# LATIGO TRAILS FILING NO. 10

### PUBLIC UTILITY PLANS

PUBLIC UTILITY PLANS FOR:  
**LATIGO TRAILS**  
**FILING NO. 10**  
EL PASO COUNTY  
FALCON, COLORADO

ISSUE	DATE
INITIAL ISSUE	9/26/24

WATER SERVICE PLAN  
 PROJECT NO. 21820-01CSCV  
 DRAWING NO.

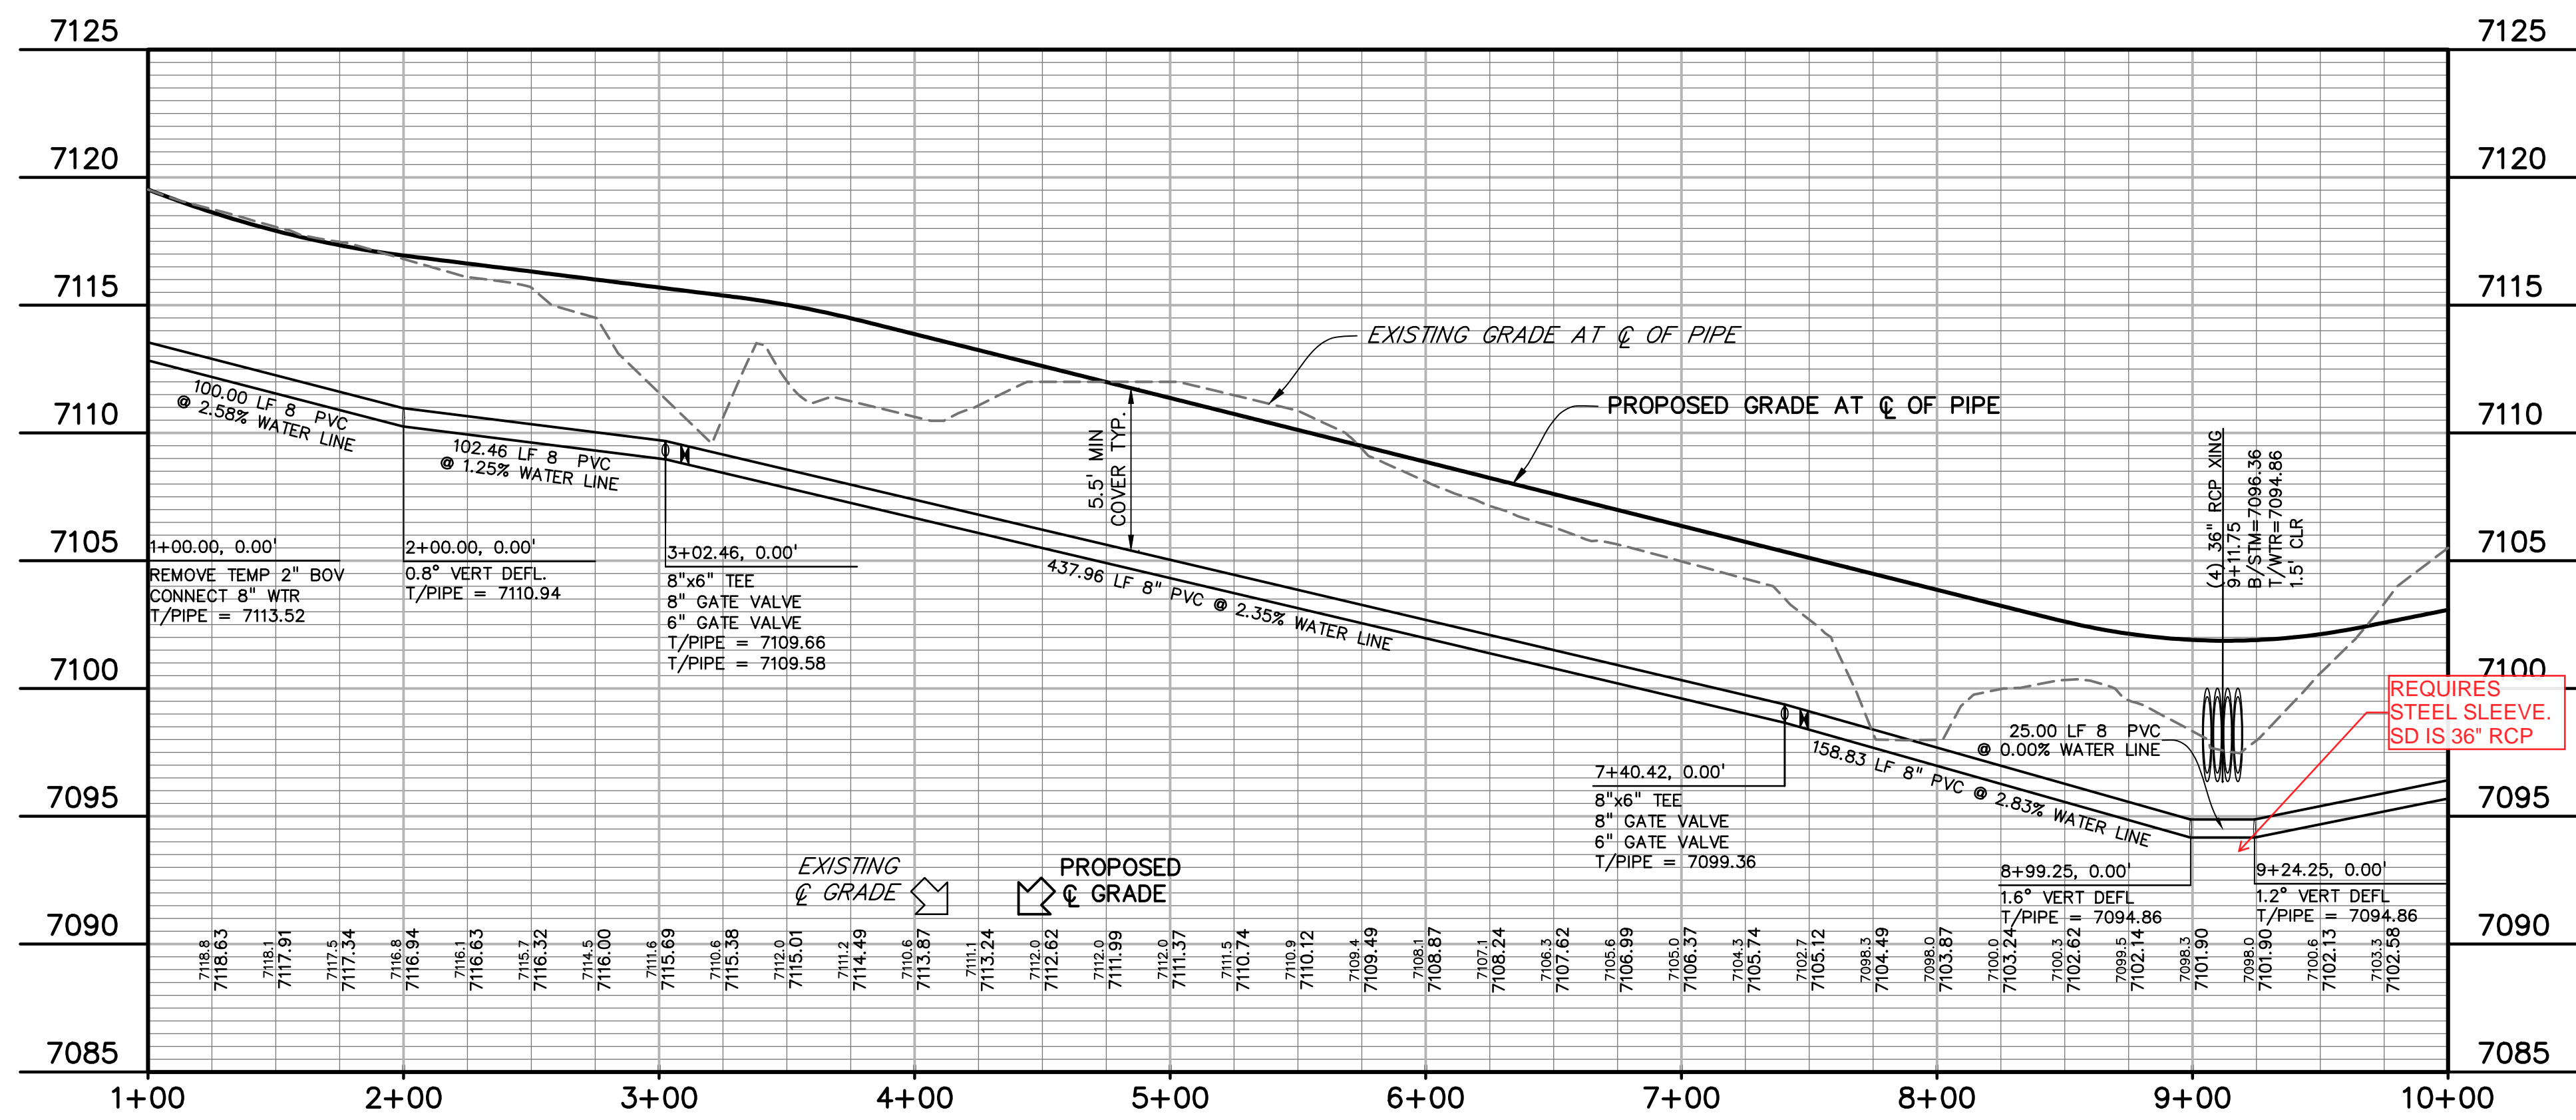
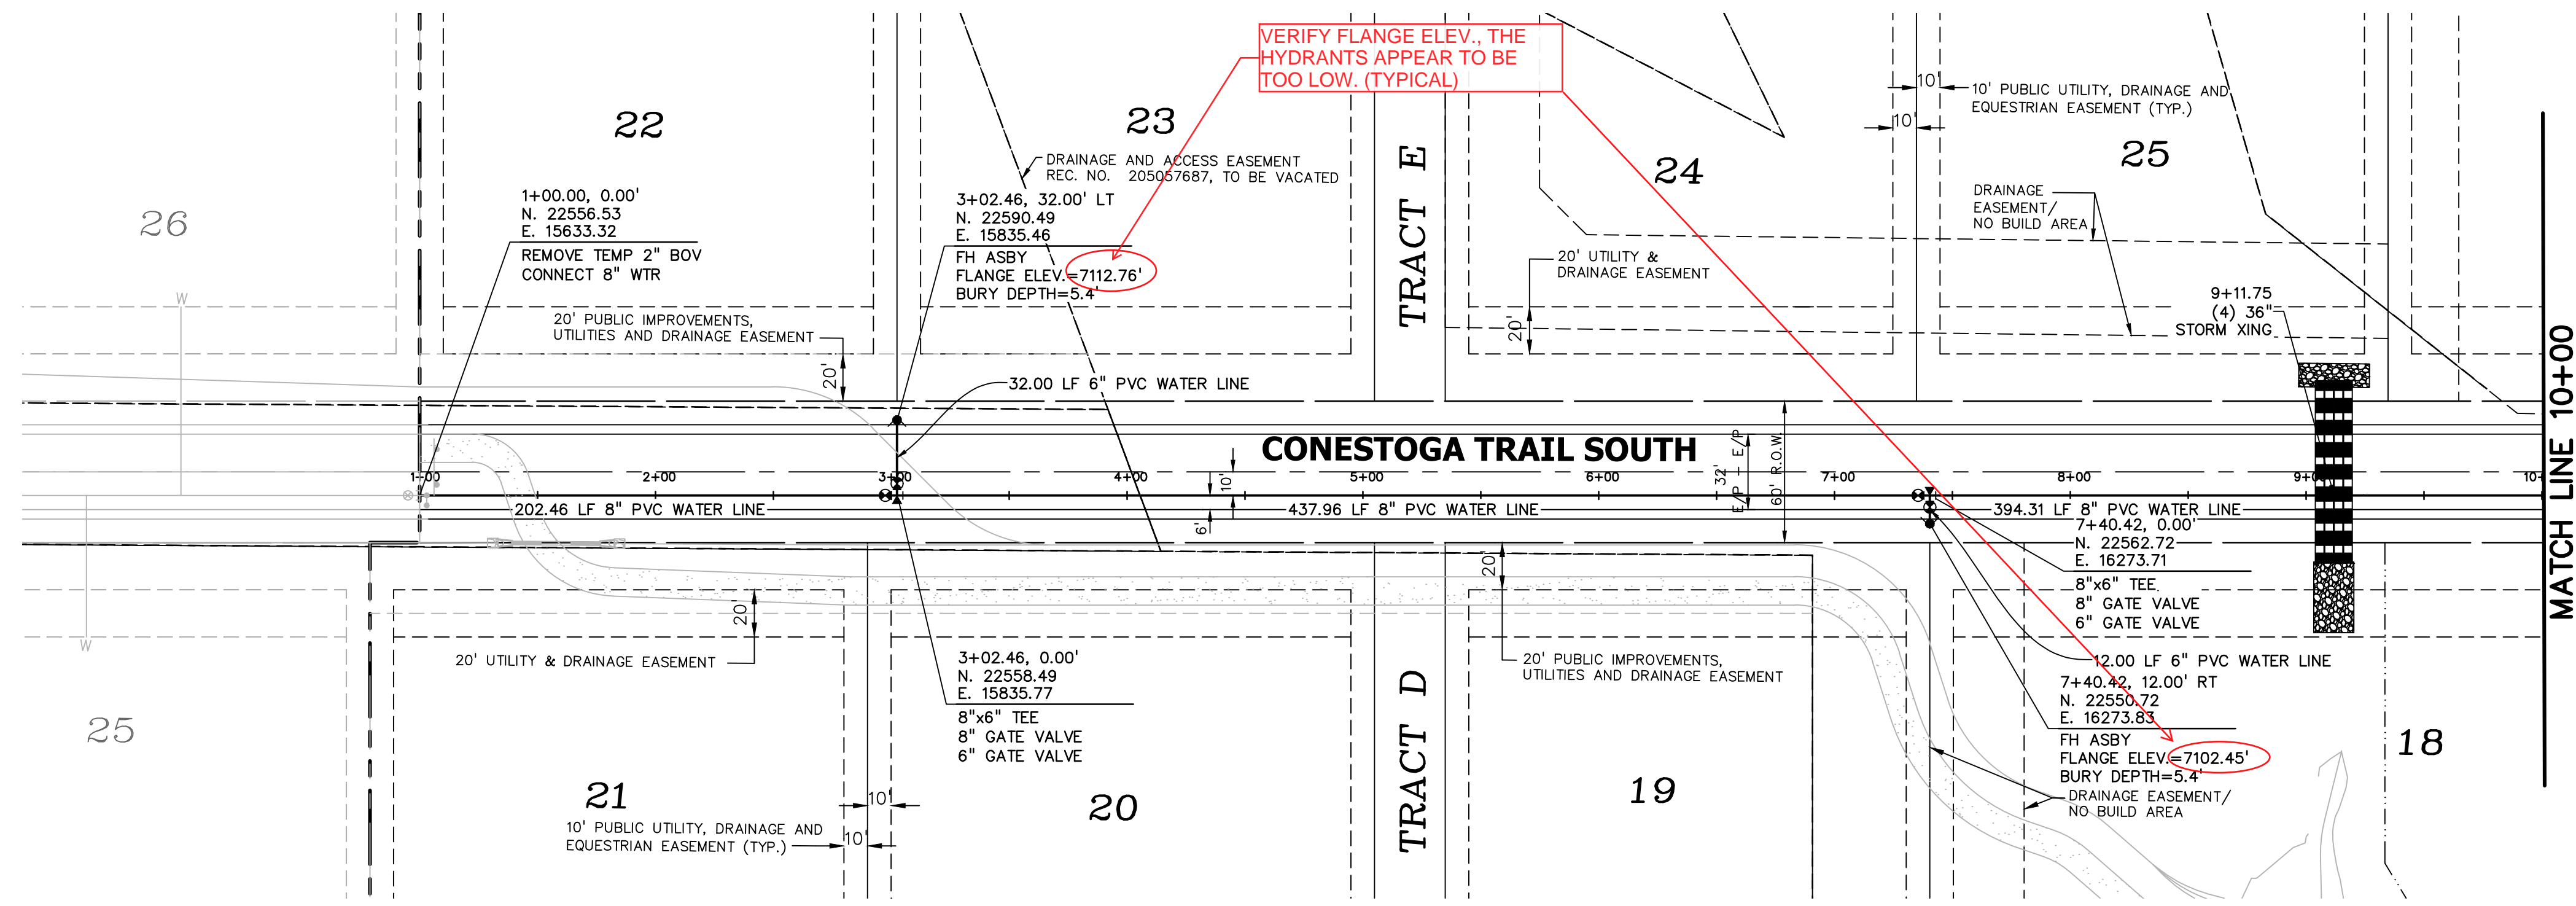
SHOW TYPICAL HYDRANT LOCATION WITH DIMENSIONS ON EACH SIDE OF THE ROAD.

**CONESTOGA TR.  
 WATER PLAN  
 & PROFILE**

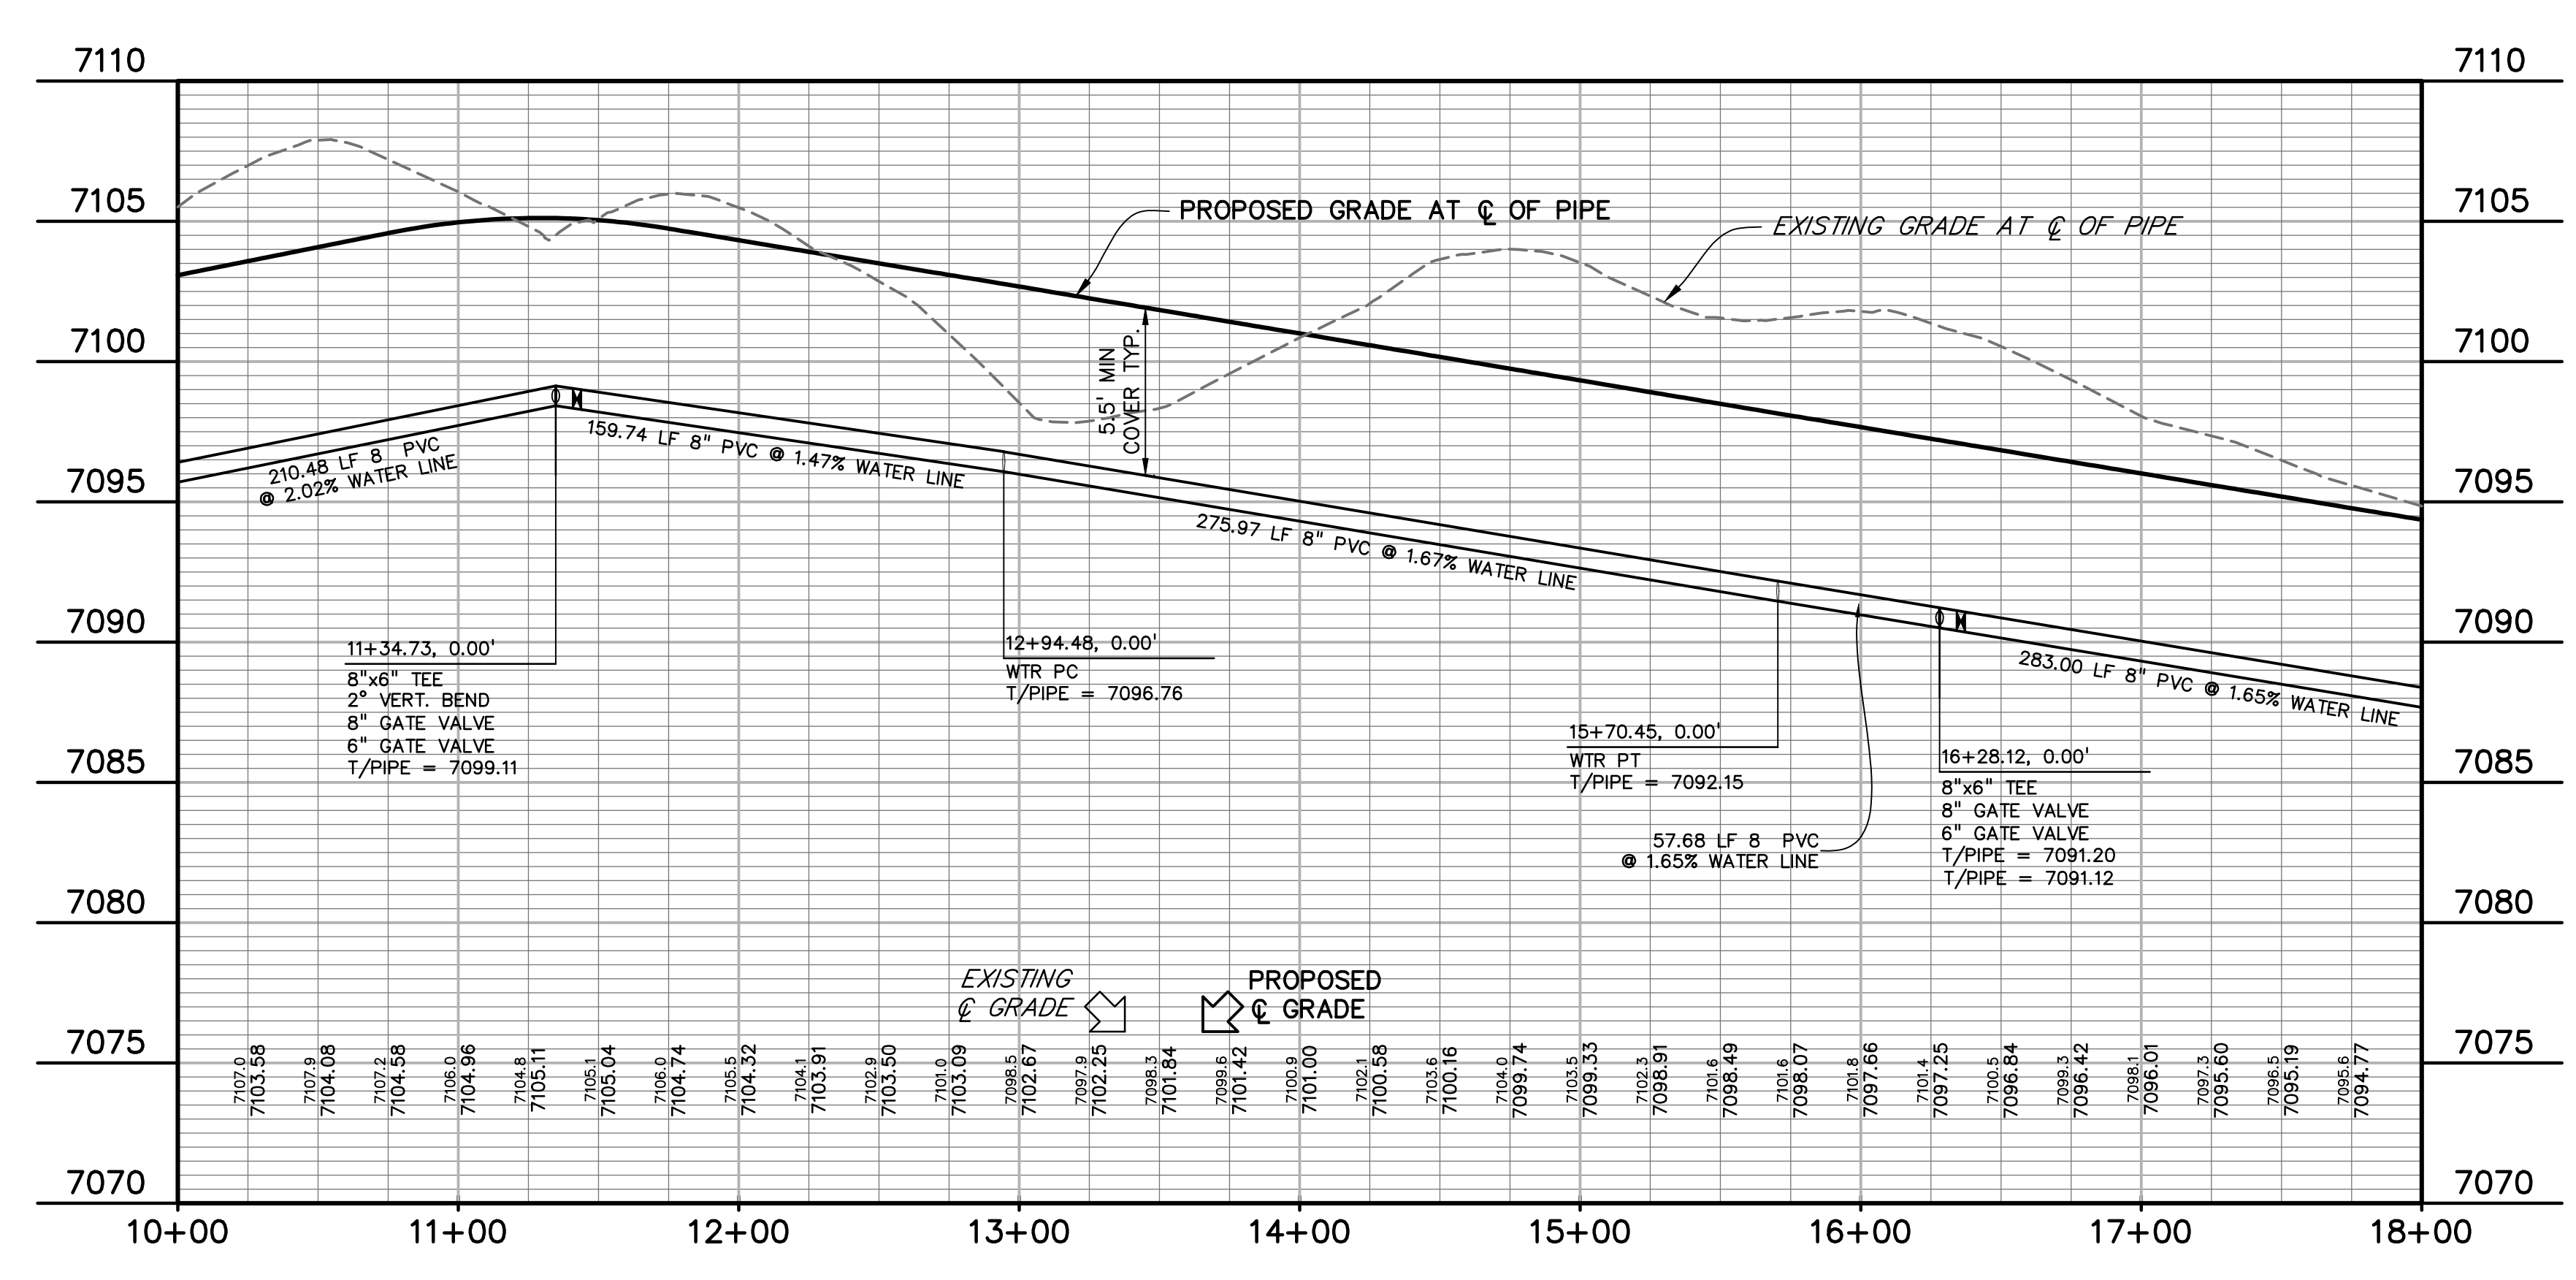
REQUIRES STEEL SLEEVE. SD IS 36\"/>
